FIELD CHANGE

TRANSMITTING RADIO, SET

AN/FRT-39B, C, D, E, F, G, H

ELECTRONICS FIELD CHANGE BULLETIN	AN/FRT-39
BUREAU OF SHIPS, NAVY DEPARTMENT	AN/FRT-40
WASHINGTON, D. C.	AN/FRT-62

Figure 2

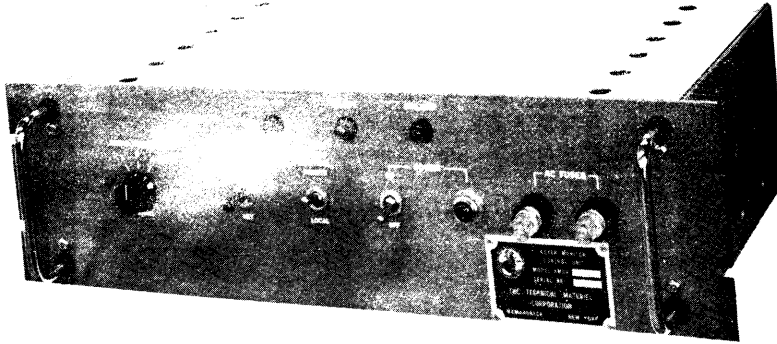
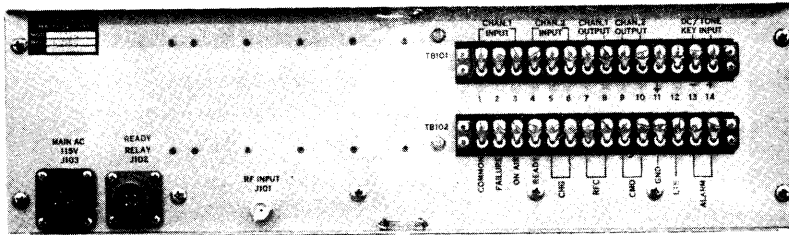
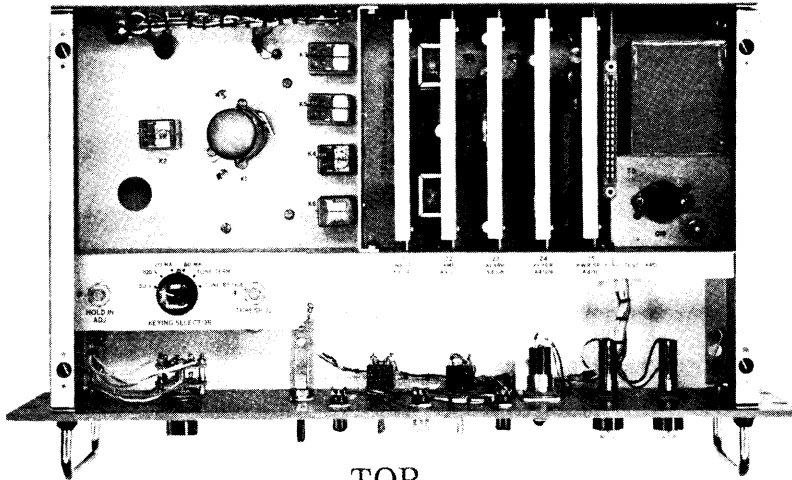
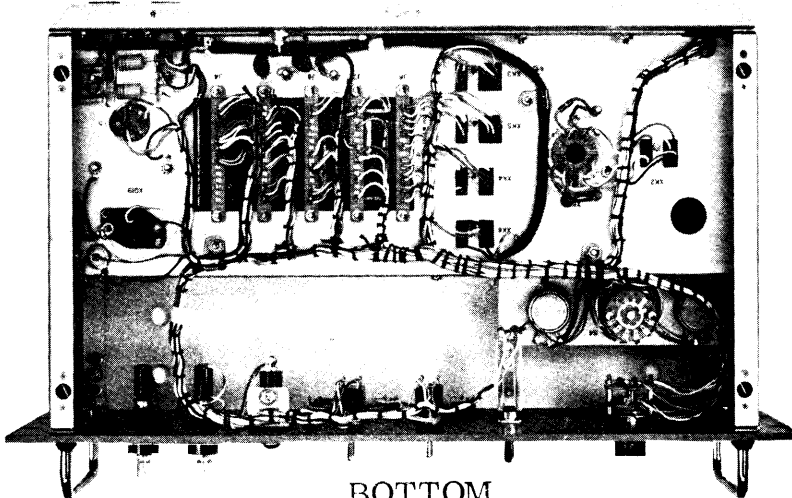
IDENTIFICATION OF ACCOMPLISHMENT: The components of this modification are listed in the list of materials required. Figure 1 indicates the physical placement of the KMCU. Figure 2 illustrates the major assembly, the KMCU, in this modification.

MODIFICATION OF MS3679

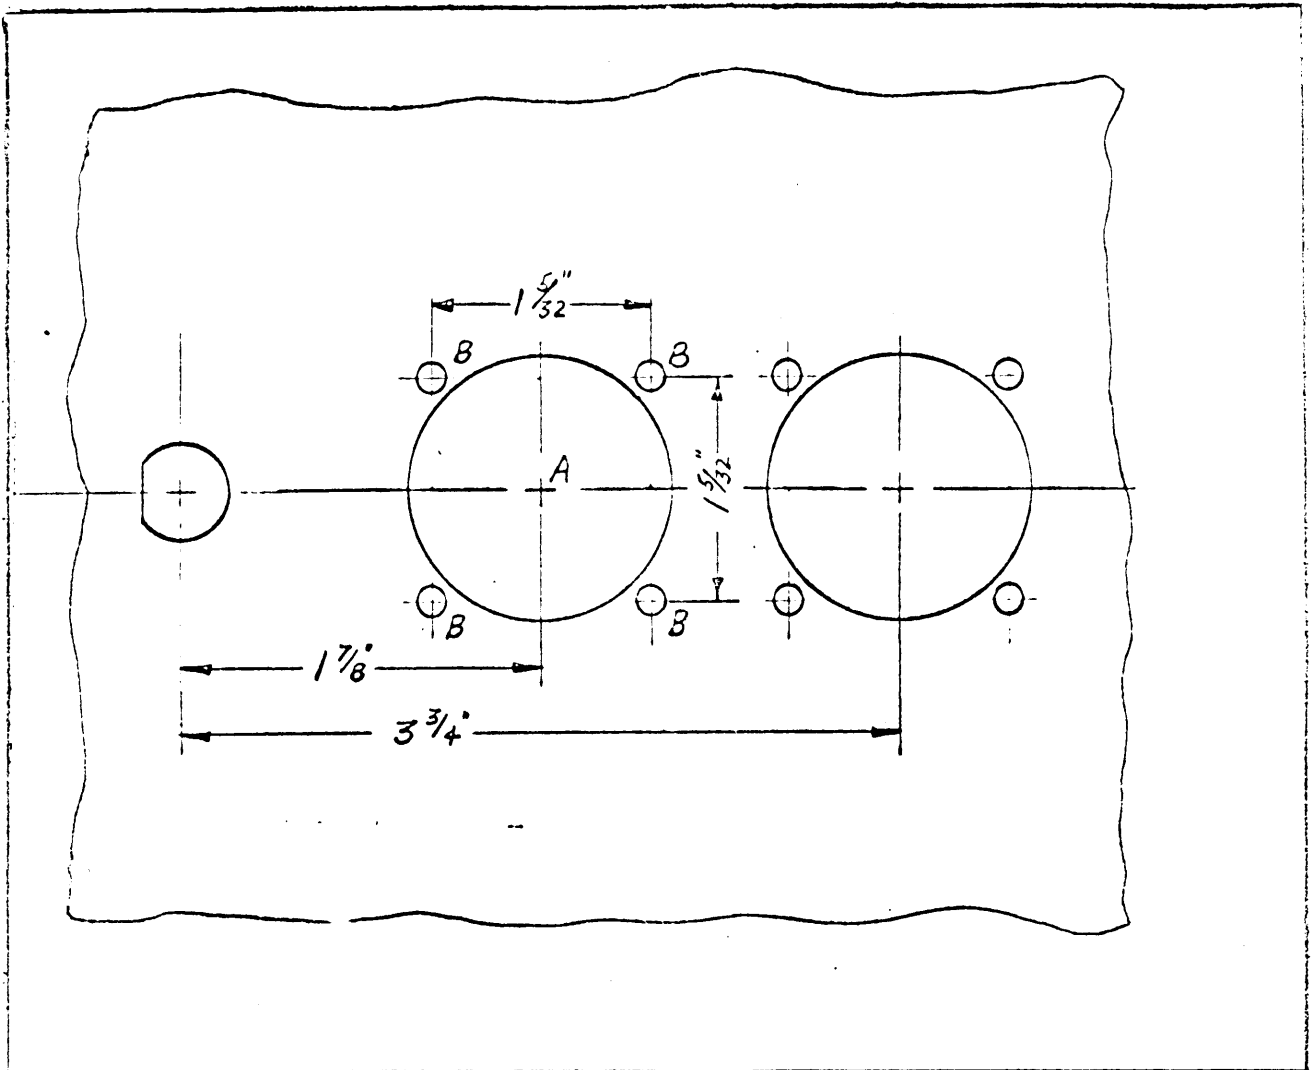
- (a) Mark MS-3679, using figure 3 for dimensions.
- (b) Using the 9/64" drill bit, 3/8" drill bit and the 1-5/16" chassis punch, modify MS-3679 as shown in figure 3.

MODIFICATION OF MS 2469

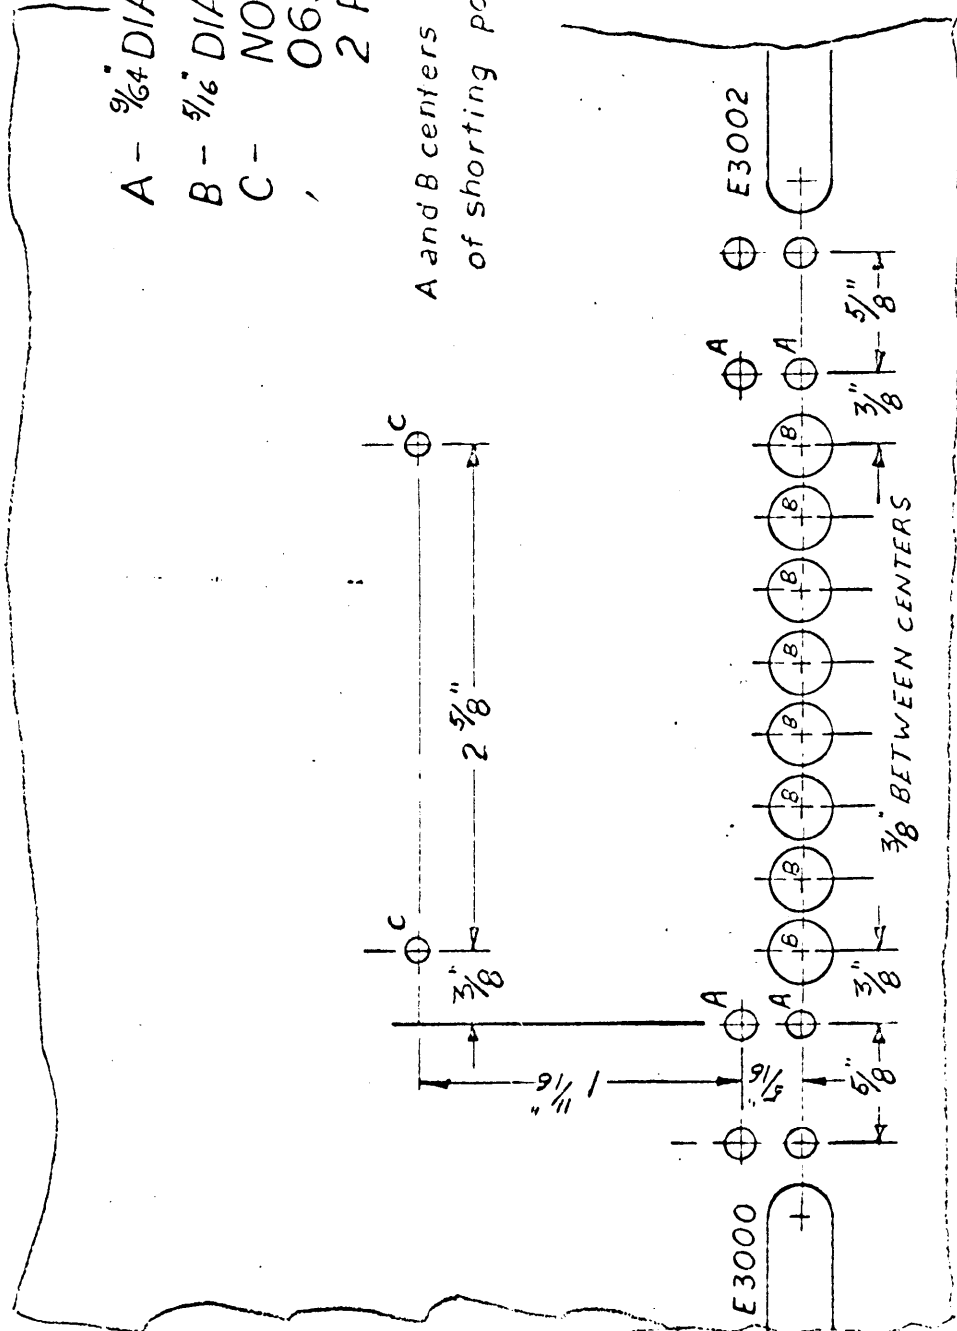
- (c) Mark MS-2469, using figure 4 for dimensions. Using the 9/64", 5/16" and the No. 36 drill bits and the 0632 UNC tap, modify MS-2469 as shown in figure 4. Using the terminal strip, insulation paper, 2 saddle plates, 4-5/8" 4-40 screws, 4 nuts, 2 lock washers and 2 ground lugs (item 32), mount the terminal strip identically as E3000 and E3002 position on the center shield. Remove J3002 from the center shield assembly. Replace with the new jack supplied (UG-492/U, item 29). Mount the UG-274/U "T" to the feed thru on the equipment side. Cut the removed J3002 (JJ-172) from the cable. Connect the PL-169 to this cable. Connect this PL-169 to the "T" on the equipment side of the center shield; solder the No. 16 buss wire to the ground lugs as is done on the other strips. Using the stamps provided, stamp the center shield as shown in figure 5. Refer to step 21 for stamping instructions. To seven lugs of the strip, running consecutively right to left from No. 14 of E3000, connect the 1000 mmfd capacitors. Connect the other end of the capacitors to the ground buss as is done on the other strips. To the eighth lug, connect a length of No. 22 buss wire to the ground buss. Position the connections on the terminal strip lugs to leave enough clearance to connect the cable in a following step.

A and B centers critical because  
of shorting possibility.

LETTERING MS 2469

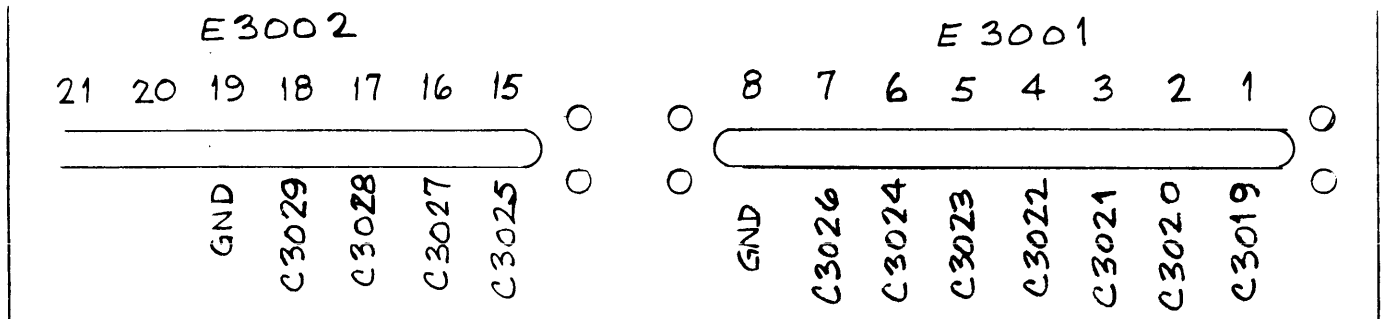
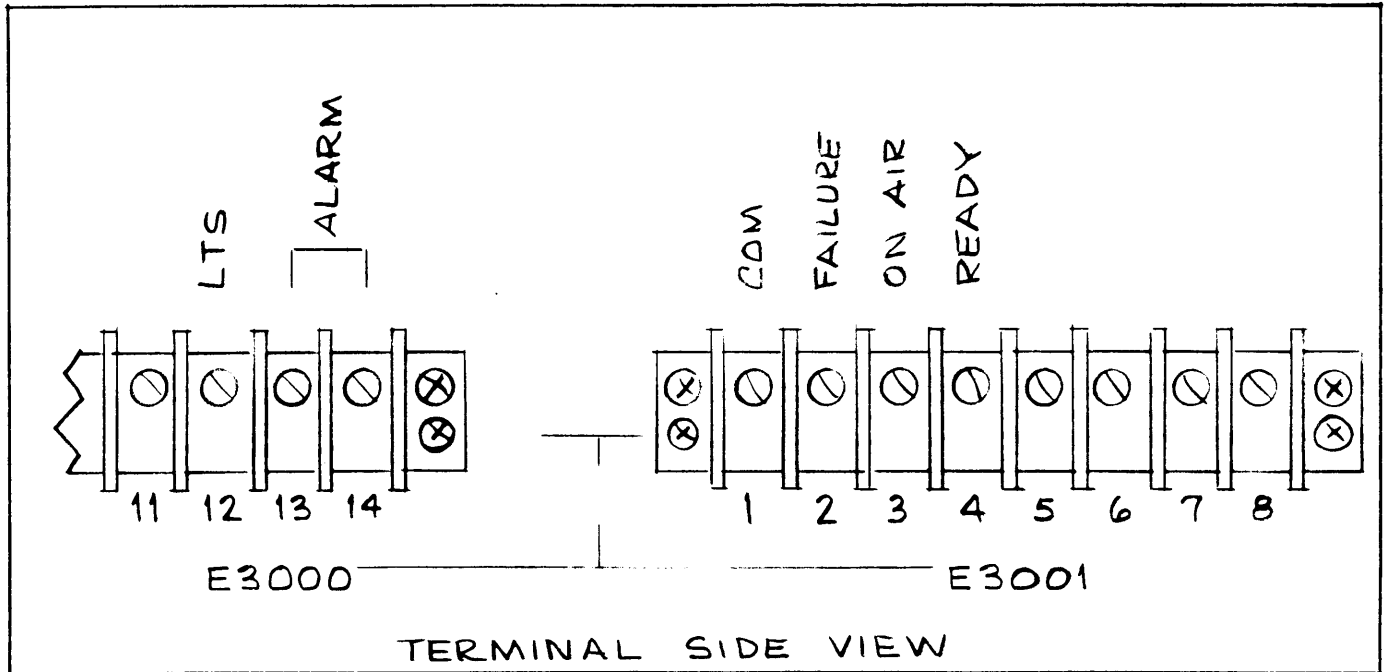
19. Remove markings on rear of center shield above terminals 12, 13 and 14 of E3000. Using items 62 and 63, mark rear of center shield above terminals 12, 13 and 14 of E3000 as shown in figure 5.

CA1031 INSTALLATION

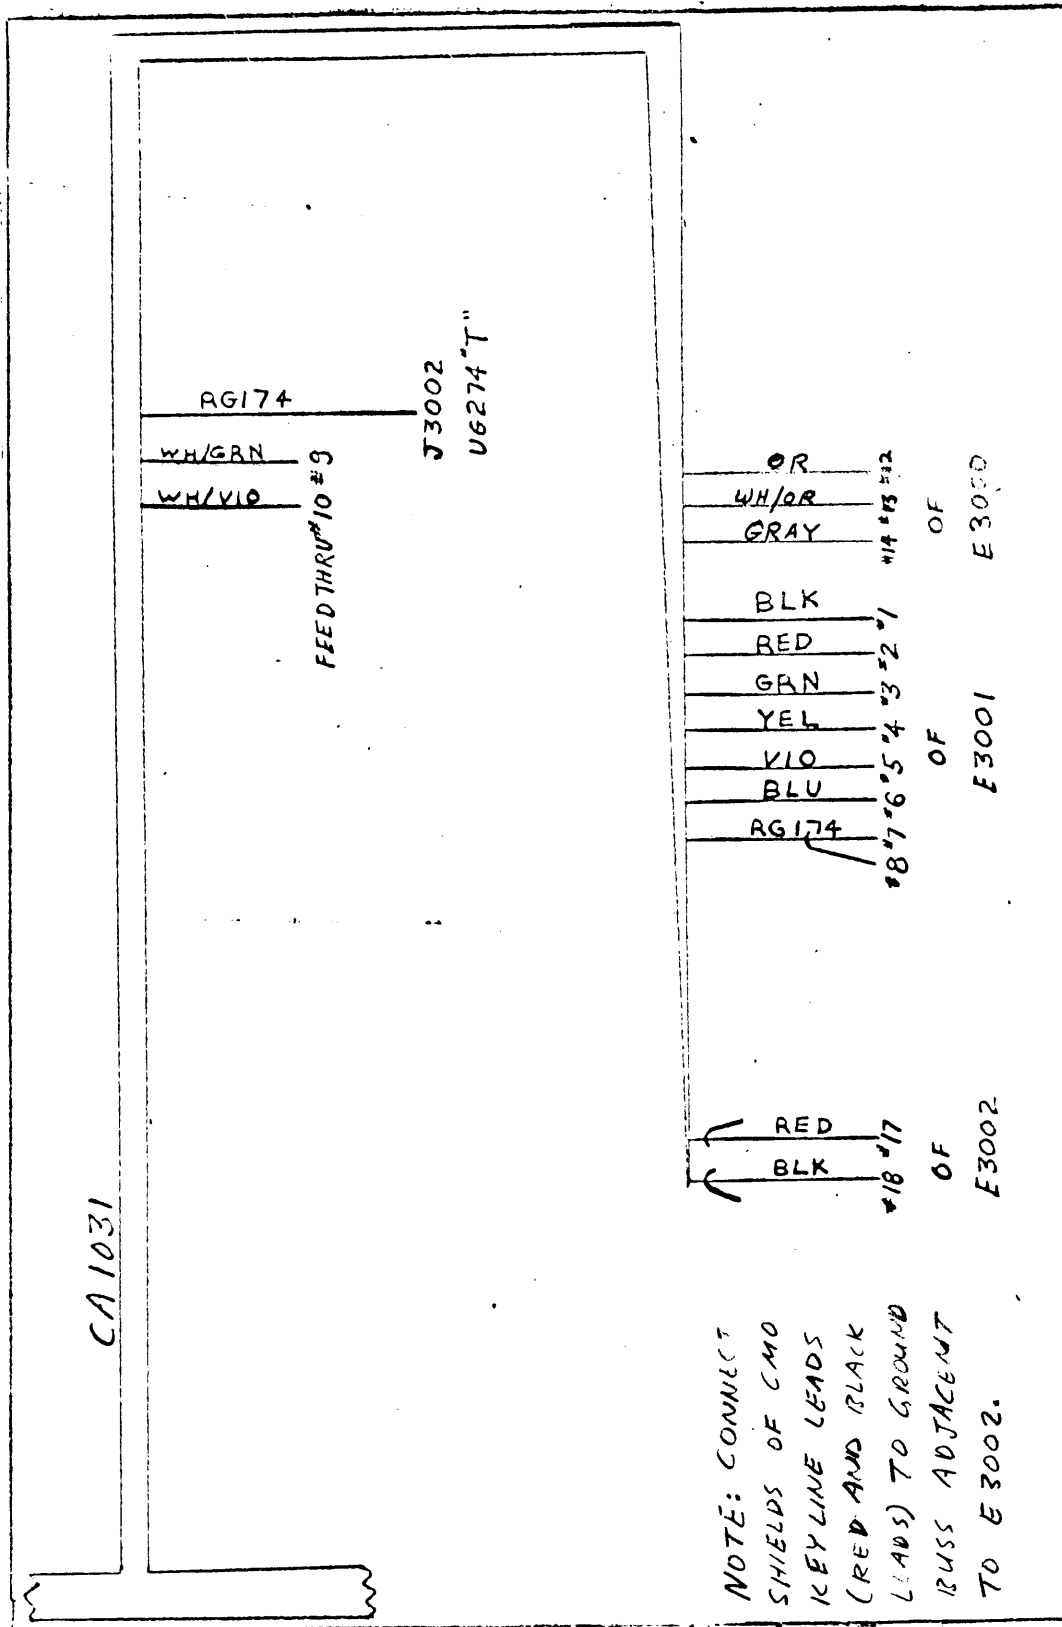
- (a) Align the center shield breakout of CA-1031 with the center shield breakout of the main cable. Lace the two center shield breakouts together. Connect and solder the leads as shown in figure 6. Along the main cable, lace the KMCU breakout to the cable as far as the TIS breakout. Do not lace the KMCU and TIS breakouts. Lace the CHG breakout along the main cable and the CHG original breakout. Leave enough slack at the plug to allow free movement during connection.

MODIFICATION OF CHG-2A

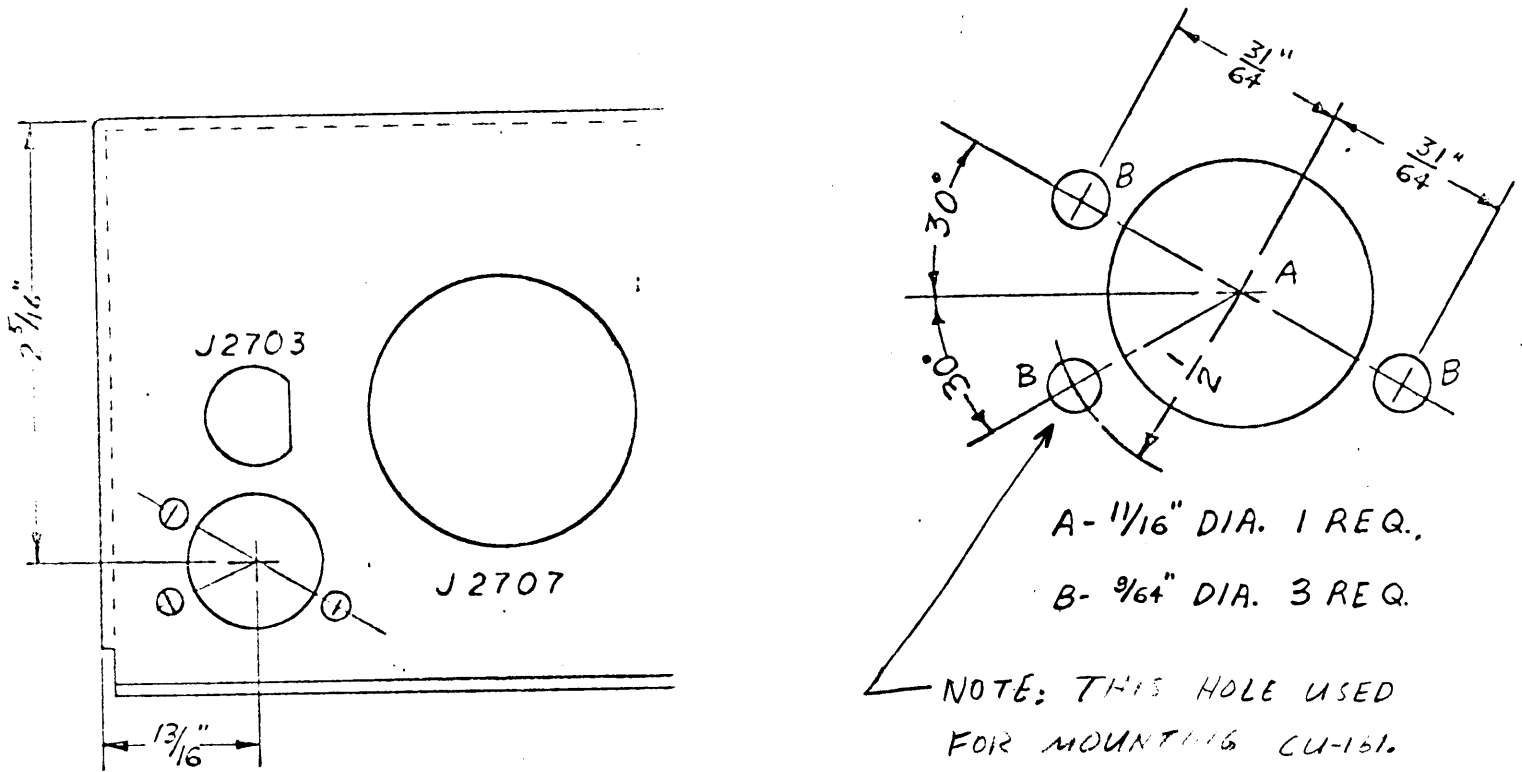
- (a) Remove dust covers from the CHG.
- (b) Mark the main chassis as shown in figure 7. Using the 9/64", 3/8" drill bits and the 11/16" punch, modify the chassis as shown in figure 7. Use extreme care during this portion as the internal wiring is in close proximity to the holes. Using the stamp provided, stamp J2708 on both sides of the chassis. Refer to step 24 for stamping instructions.
- (c) Using three 5/16" 4-40 screws, nuts and lockwashers, mount the JJ-119-2 of CA-1028 internally and CU161 externally. Route the cable along the main harness and lace. Connect the orange wire to the orange wire on C2773. Route and lace the white/orange wire under the tube and along the main harness to the B+ switch. Connect the white/orange wire to the junction of the switch and the coil L2101.
- (d) Replace the dust covers.

FIGURE 1

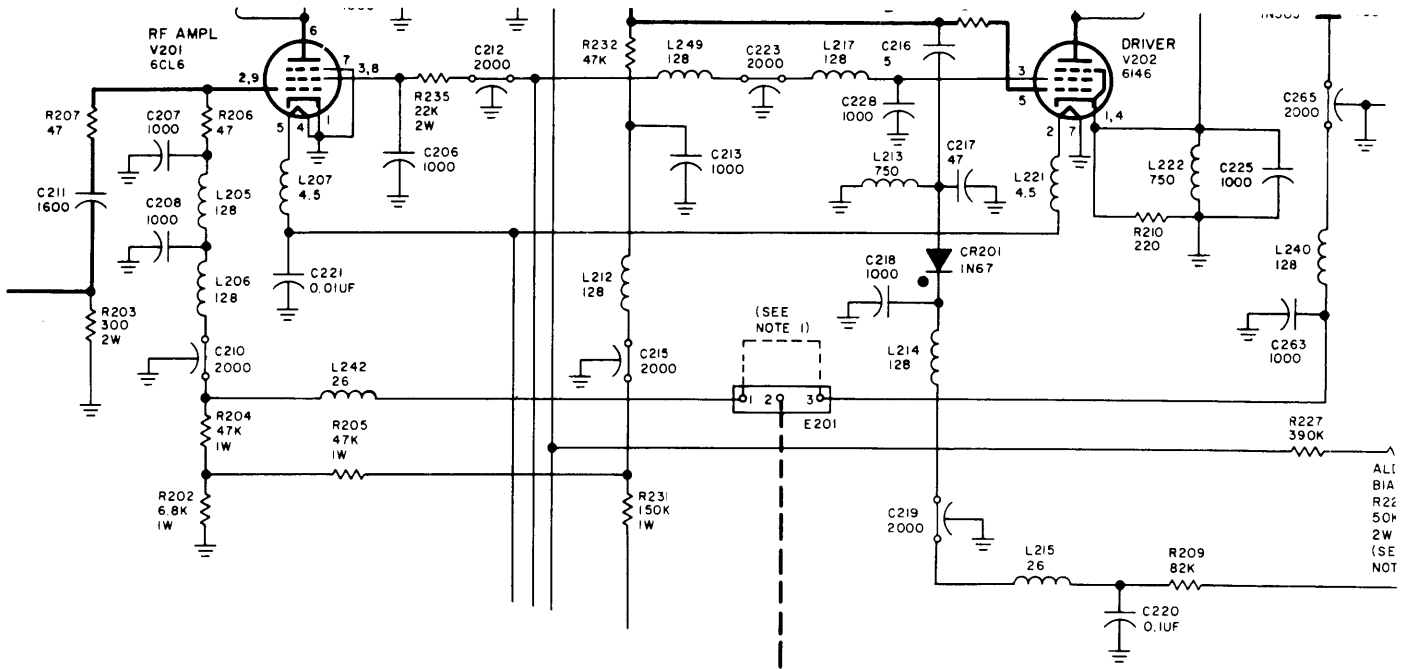
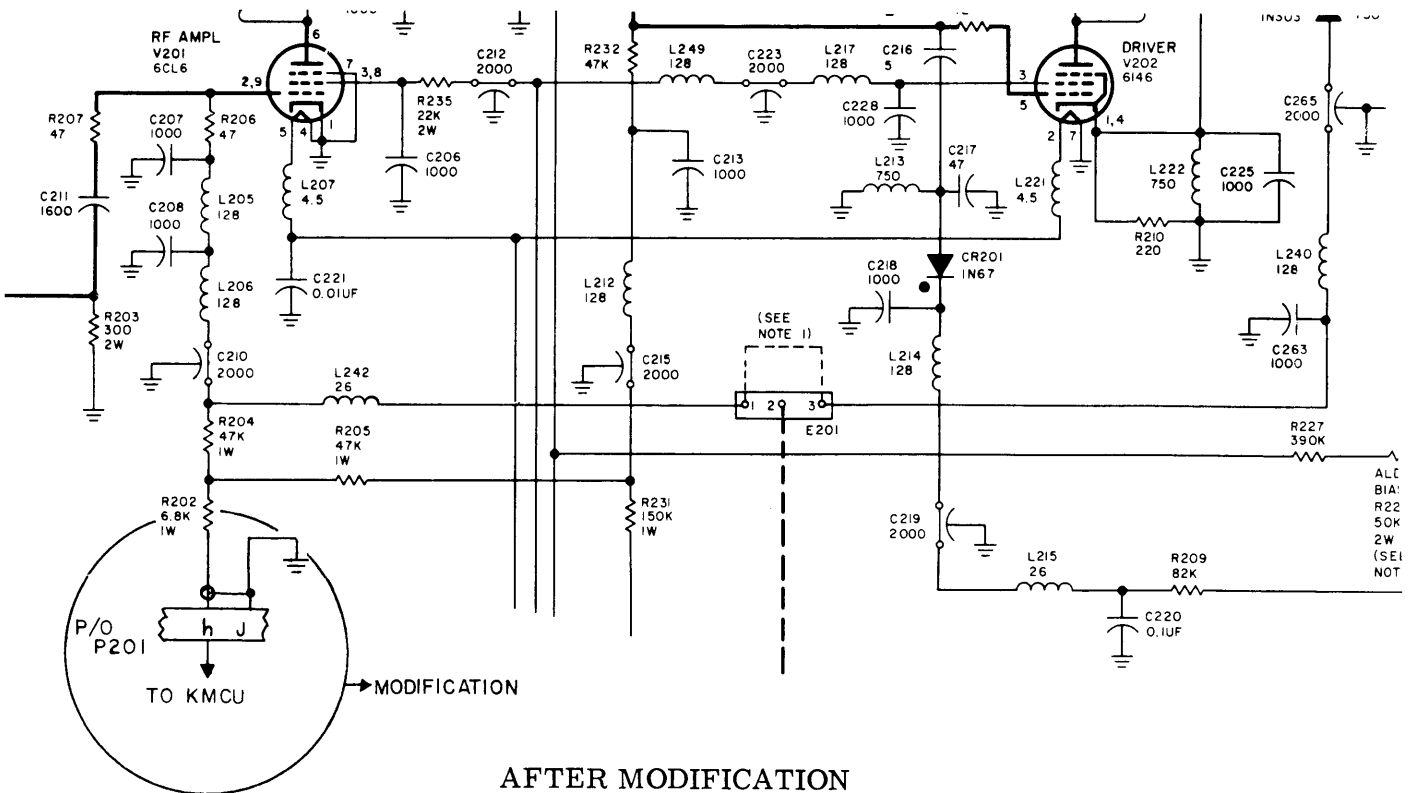
(b) SCHEMATIC DIAGRAMS (Section 6). - Schematic diagrams given in section 6 of the maintenance manual should be amended as shown in figures 1, 2, and 3.
